Certificate of Appropriateness

2722 W. STATE ST. Concordia Historic District

PTS ID 86892 COA, exterior repairs

Approved method and material form for porch floors.

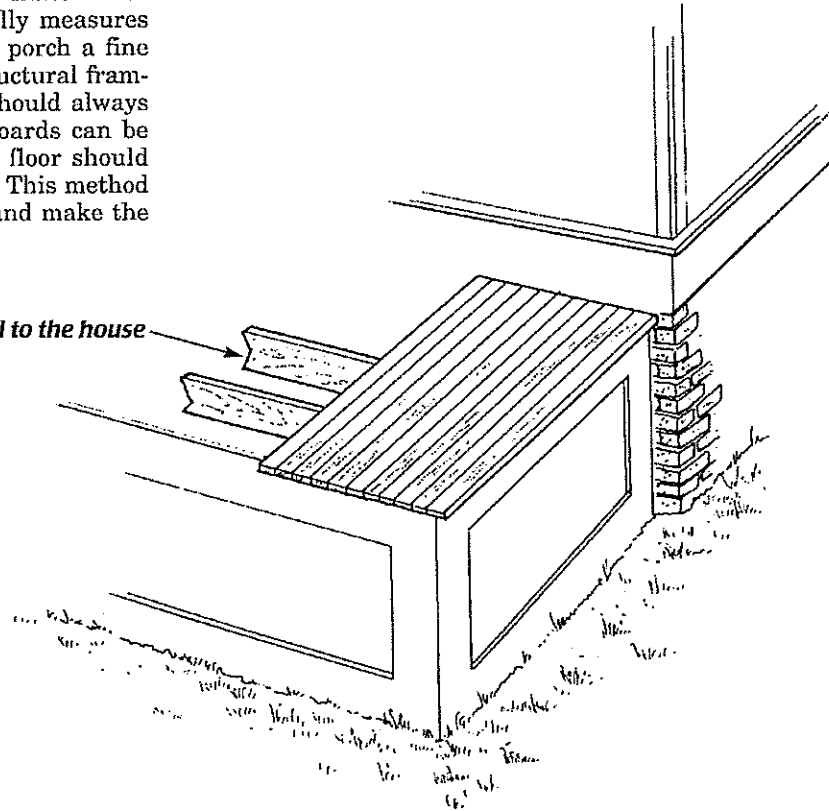
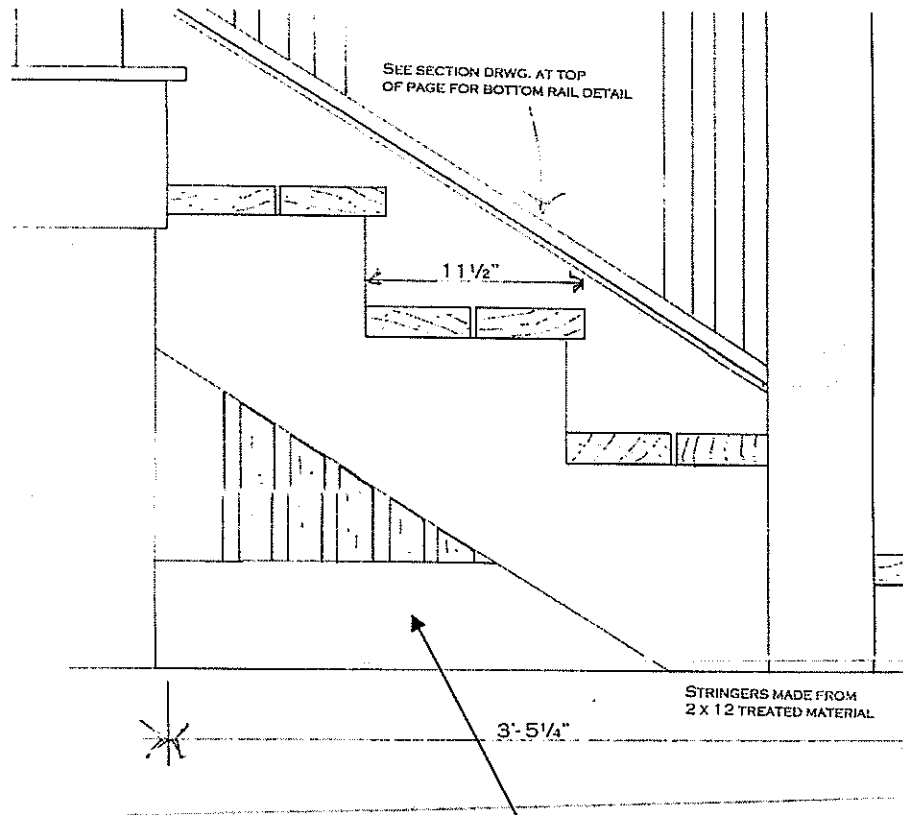
Existing porch floor to be replaced with new tongue and groove material. Gapped decking boards are not permitted. Tongue and groove material may be $\frac{3}{4}$ " or $\frac{5}{4}$ " in thickness, but must be consistent in size on the entire porch deck

Detail of handrail and bottom rail for front porch steps.

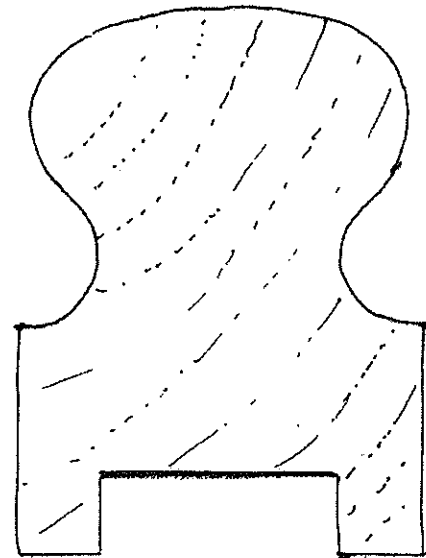
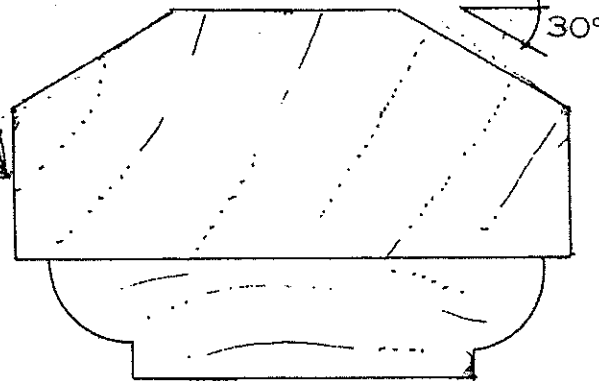
Rebuild front porch steps, railings and newels. Existing spindles to be re-used.

Note: bread loaf style handrail can be purchased from many vendors. Naturally decay resistant wood is recommended

Detail of newel posts for bottom steps. Post is made from a 4 x 4 wrapped with clear finish material. Post top is made from 2x material beveled on a table saw. A 3/4" cove molding is installed beneath the 2x cap.

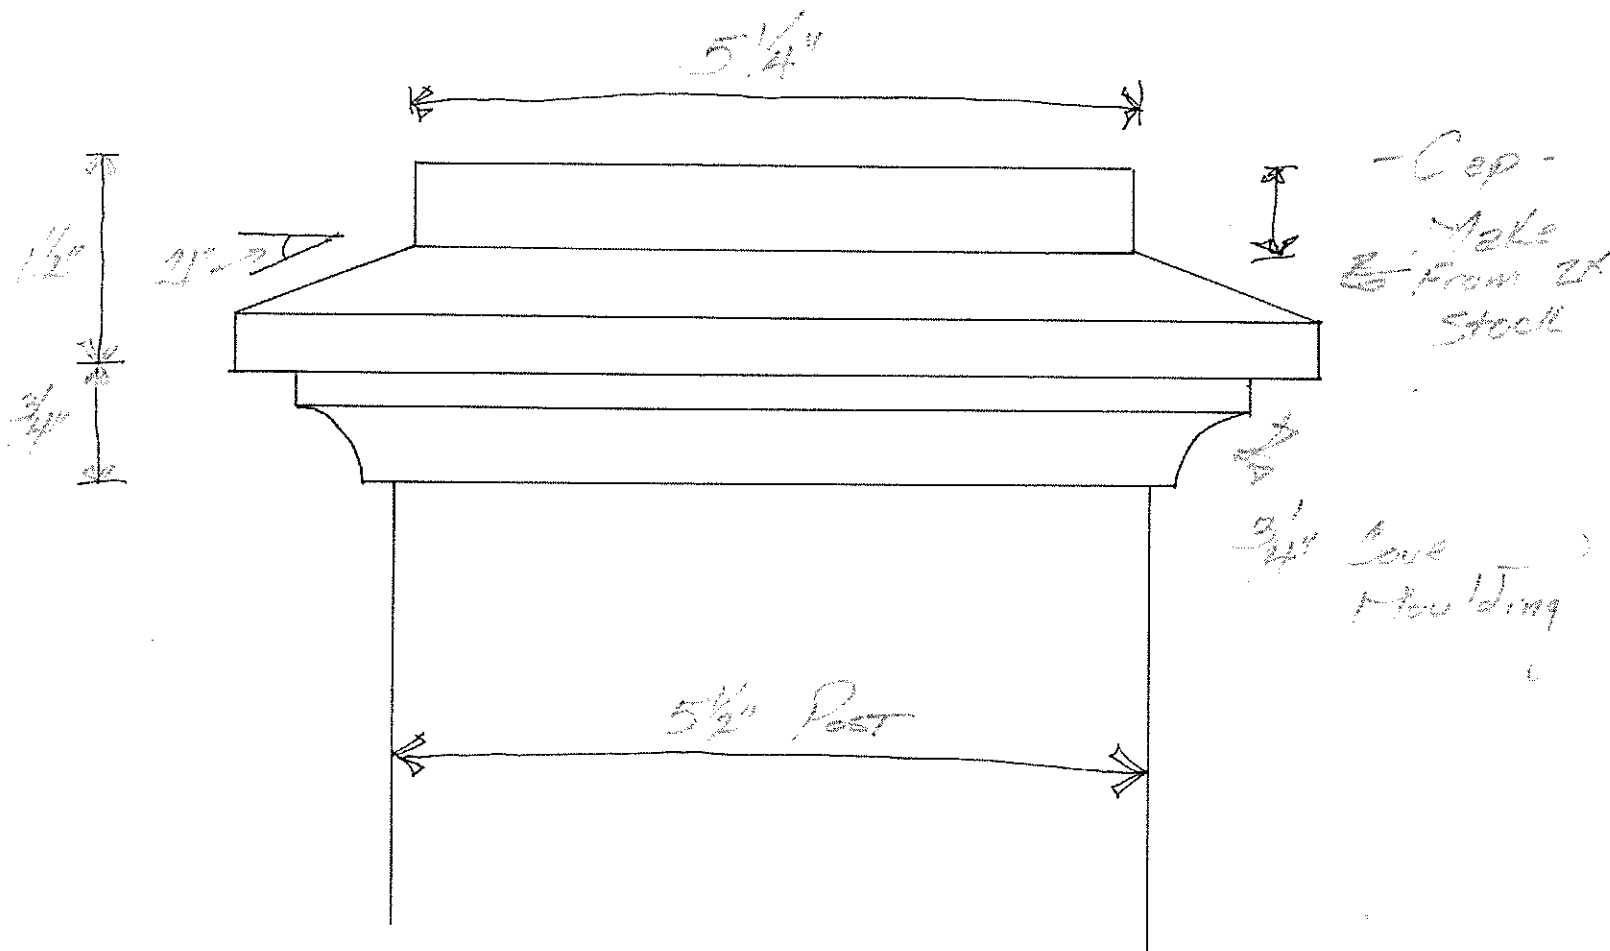
Skirting for porch steps must have a complete frame around it as illustrated. Any skirting replaced around the porch deck must have a matching framed skirting.

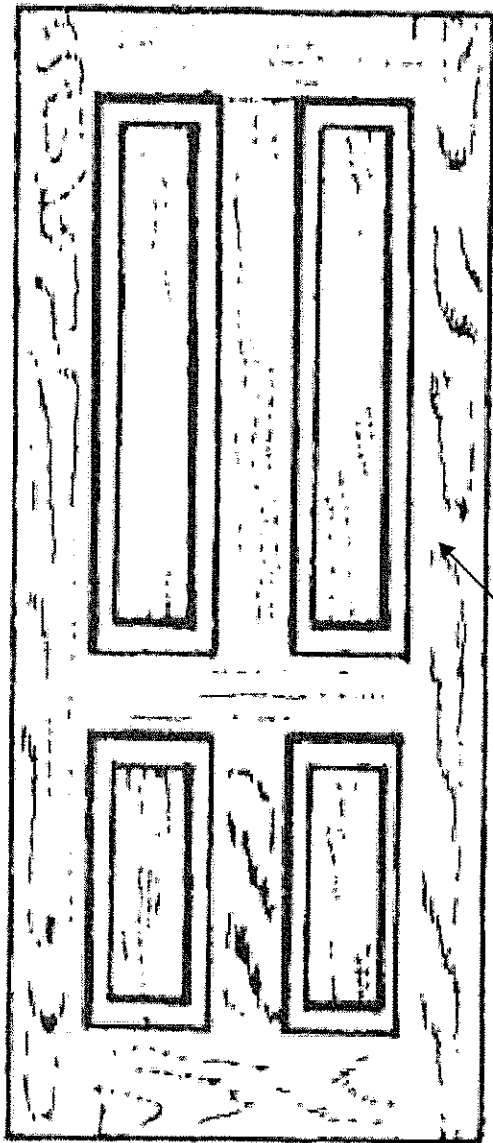
Though not a requirement, the use of traditional radially-sawn, vertical grain clapboards for replacement is highly recommended as an economical means to ensure that the wood will hold paint better, last longer and resist warping. It is also has the same profile as the original clapboards on the house, unlike most modern clapboards.
